North Bethesda Conference Center Parking Structure, Mandatory Referral No. MR2016017

Description

SECTION 1: RECOMMENDATION

Figure 4: Proposed Site Plan

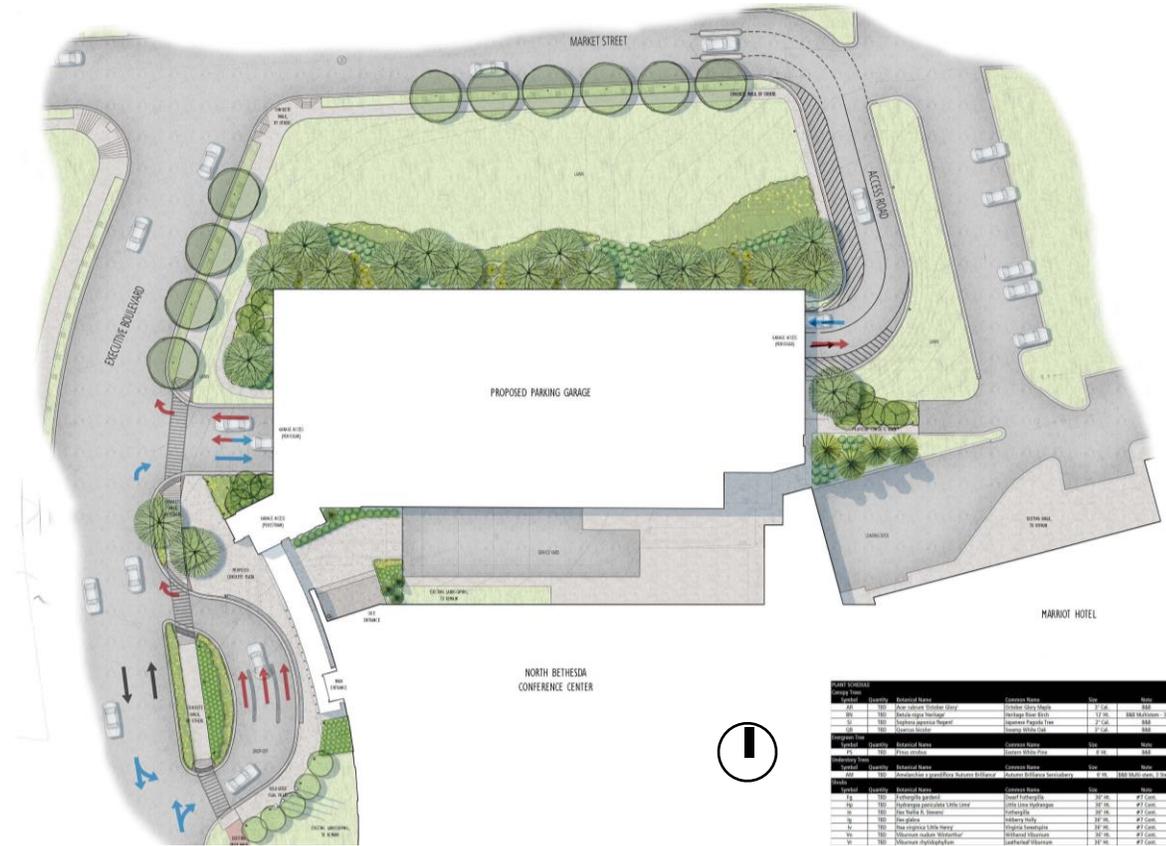
5. Provide adequate signage inside the garage to notify parking customers that there are no left turns permitted at the Executive Boulevard exit.
6. Provide special paving treatment to highlight the shared-use path across all driveways along Executive Boulevard.

In January 2011, White Flint was designated as the State's first bicycle-pedestrian Priority Area. In addition, Executive Boulevard is part of the Recreation Loop shown in Map 49, page 59 of the Sector Plan. Given the potential conflicts between bicyclists and pedestrians on Executive Boulevard and the vehicles entering/exiting the proposed garage, Staff is recommending special paving treatment for the shared use path crossing the project's driveways on Executive Boulevard (Comment No. 6).

Figure 5: Parking Structure Elevations (East and West Elevations)

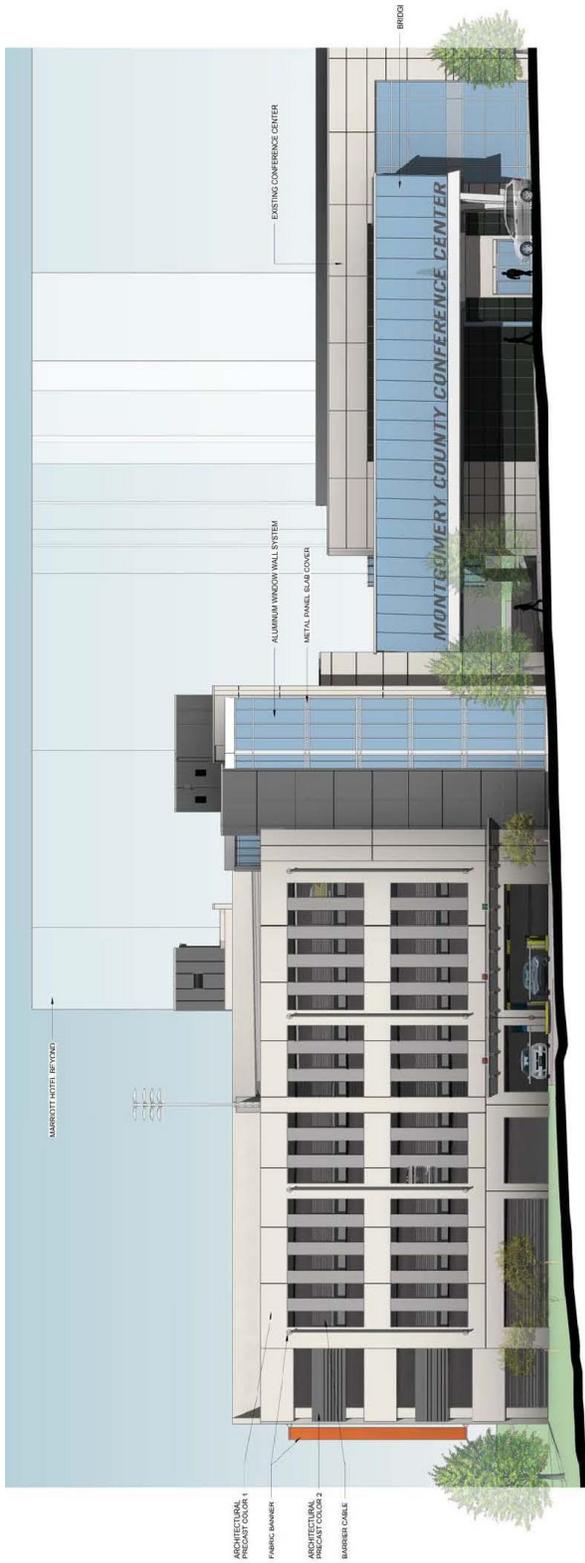
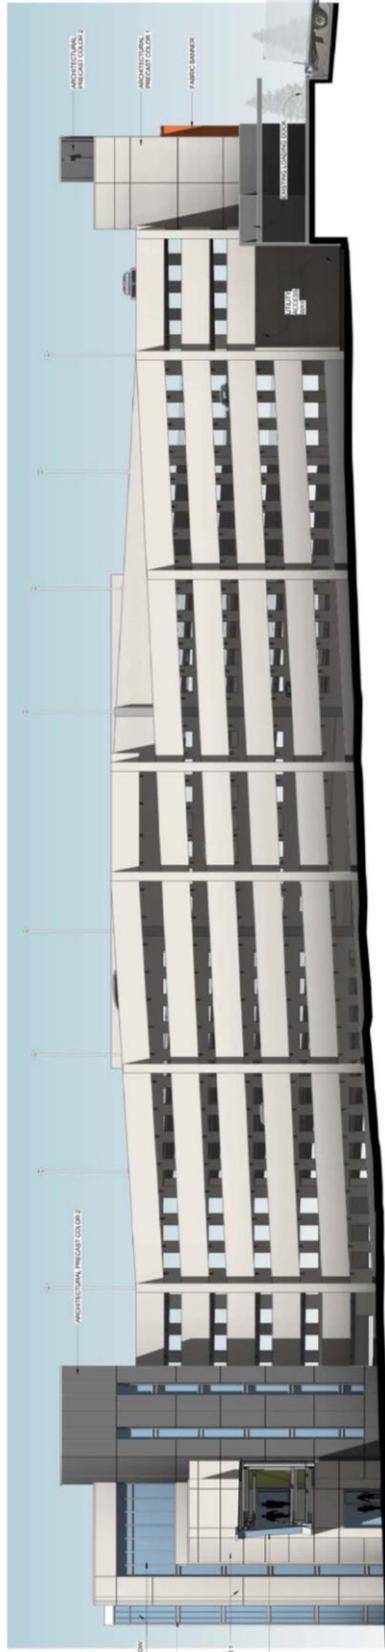
7. Include artwork, or incorporate green-wall treatment, to enhance the appearance of the facades facing Executive Boulevard and the new street B-10.

The proposed parking structure does not include a living wall or public art at the ground level. Therefore, staff recommends that the Applicant include artwork, or incorporate green-wall treatment, to enhance the appearance of the B-10 and Executive Boulevard facades until future development on the interim open space occurs.
